Re: Liberty Dialysis-Rio Rancho, 5751 McMahon Blvd.

Final Certification Of Occupancy

Re: Additional Information for Drainage Certification to obtain Permanent CO 5751 McMahon Blvd. Liberty Dialysis - Rio Rancho (A-11/D013)

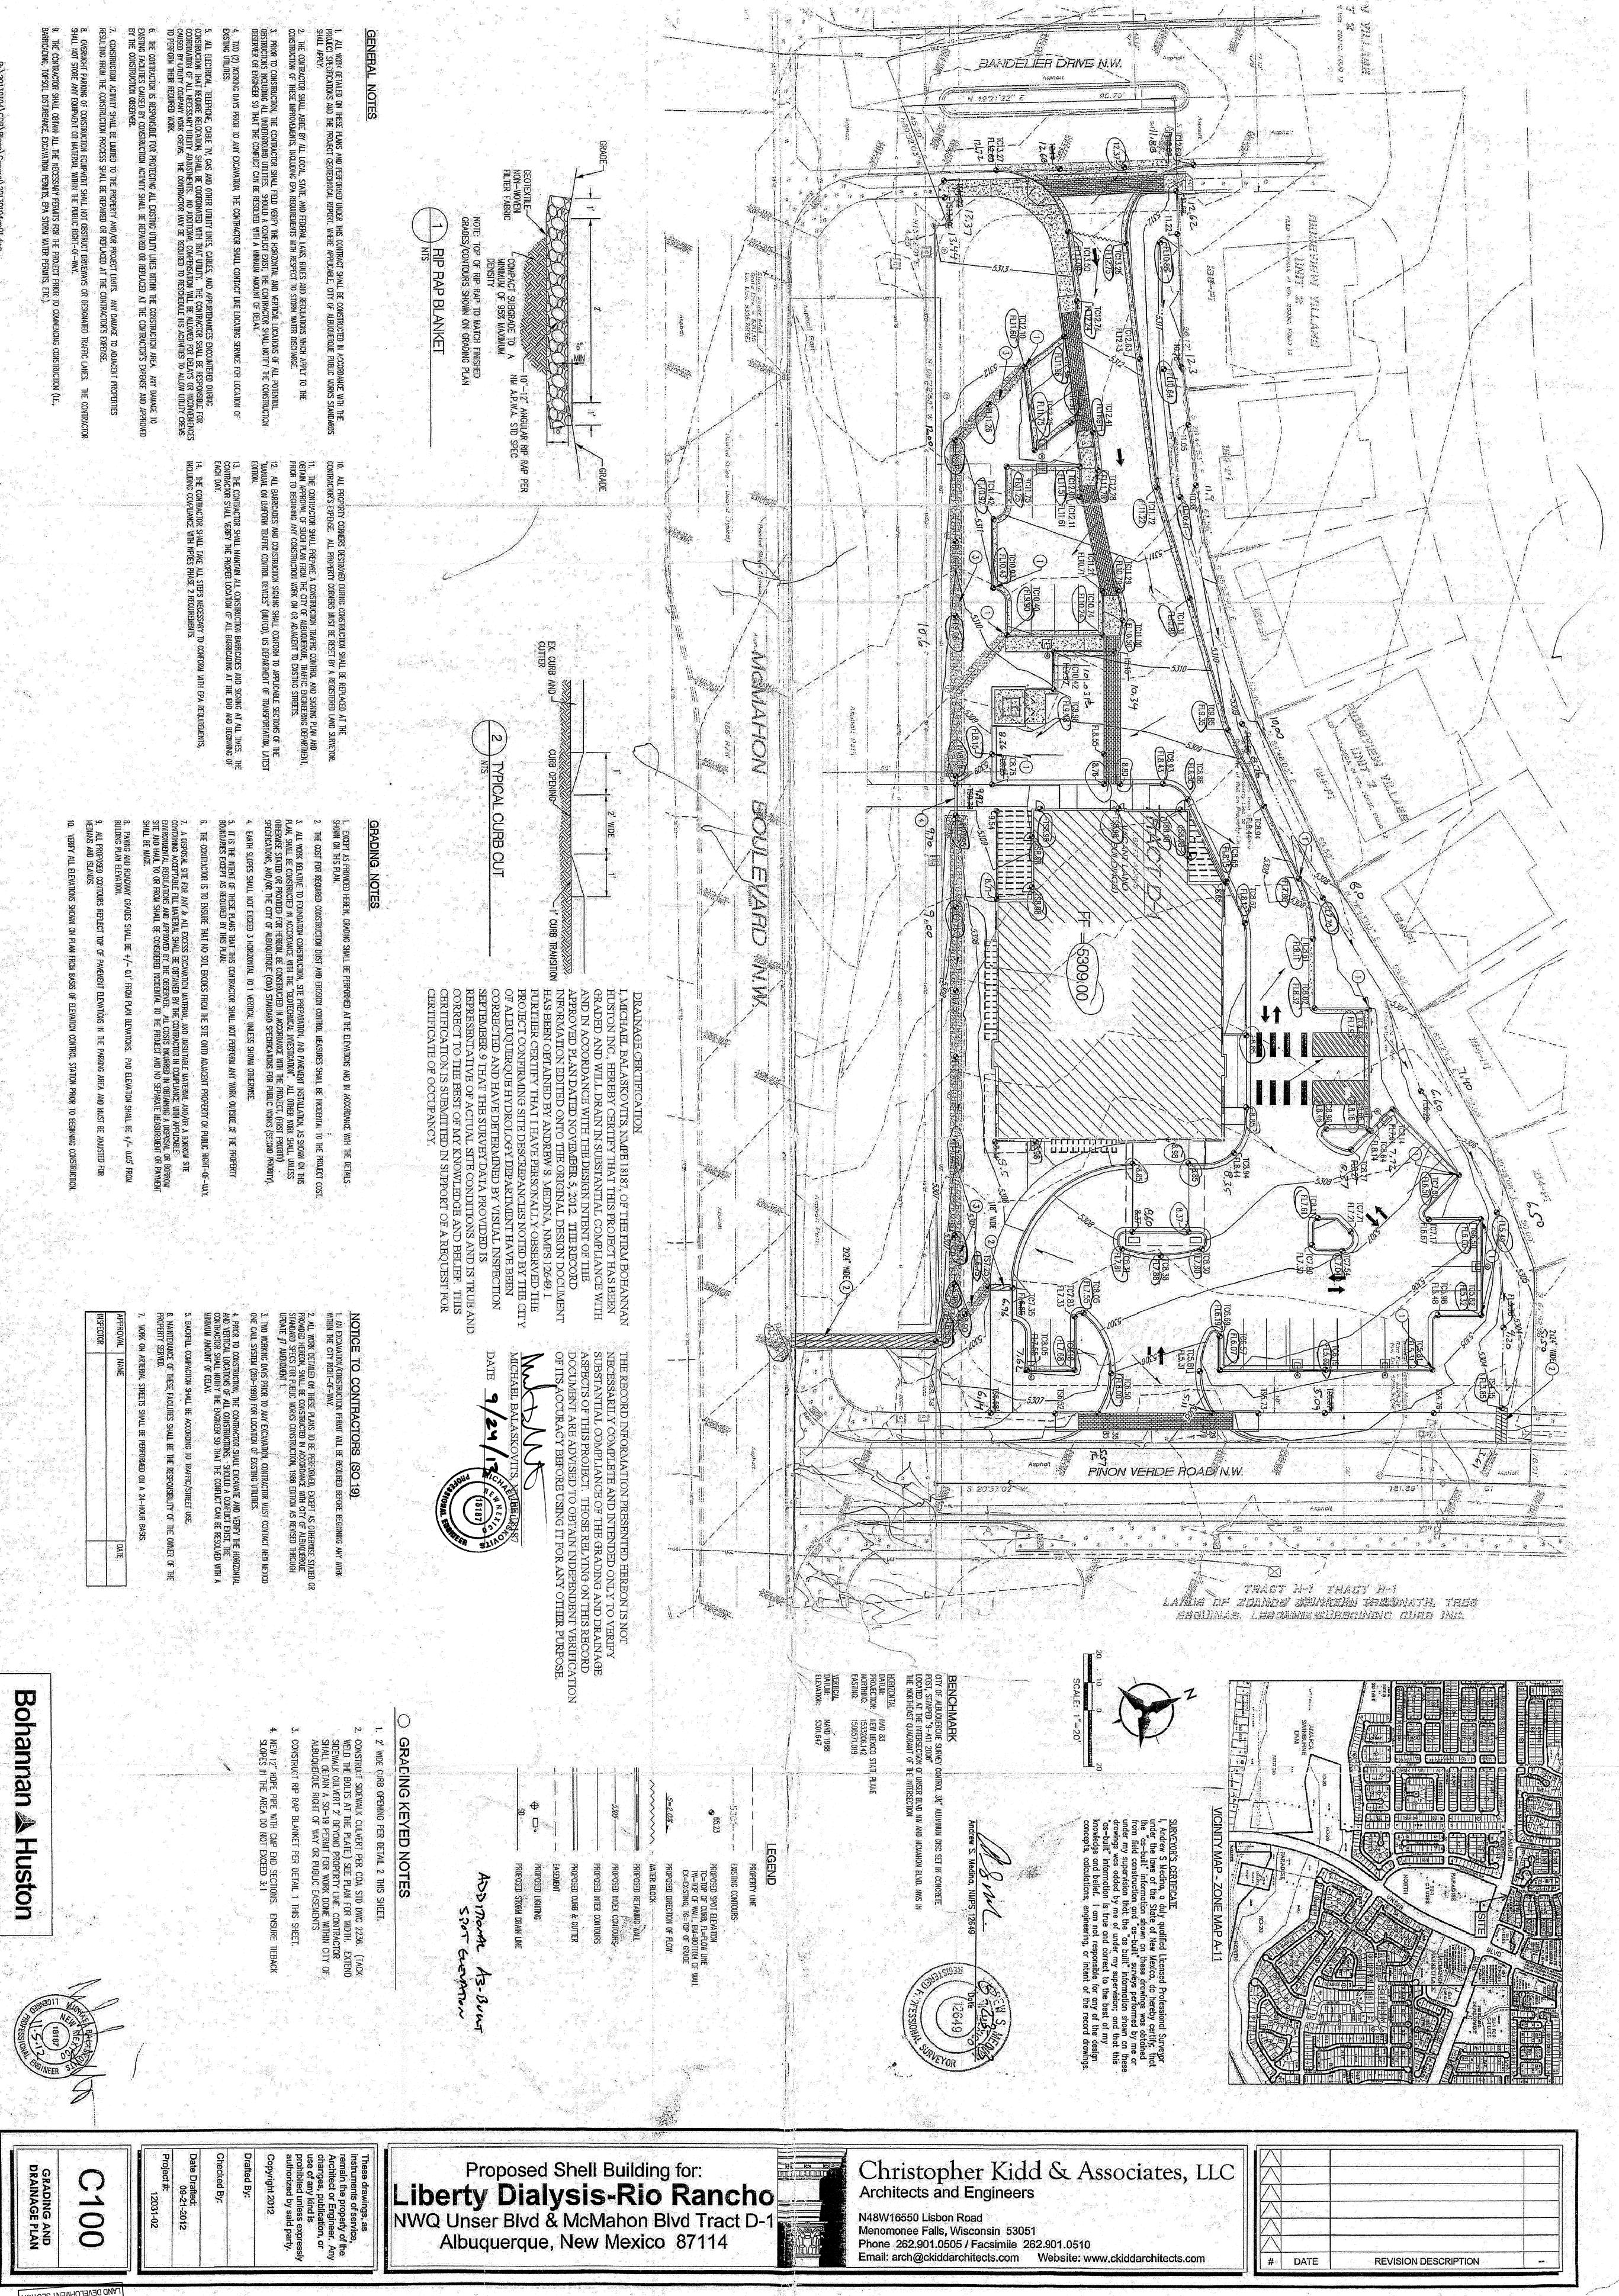
- 1. Provide a more defined swale from the curb opening to the invert of the sidewalk culvert at the northeast corner of the site.
- 2. Ensure all riprap downstream of curb openings was constructed such that it is lower than the elevation of the curb opening and positive drainage occurs, preventing ponding within the parking lot.

Based on the attached pictures, the swale has been defined appropriately. In addition, it was determined that the contributing basin is less than 1cfs and the swale constructed has the capacity for this drainage at a 4% slope.

The contractor has also informed me that they have lowered the rock in the areas you defined during our conversation and that positive drainage occurs within these areas as well.
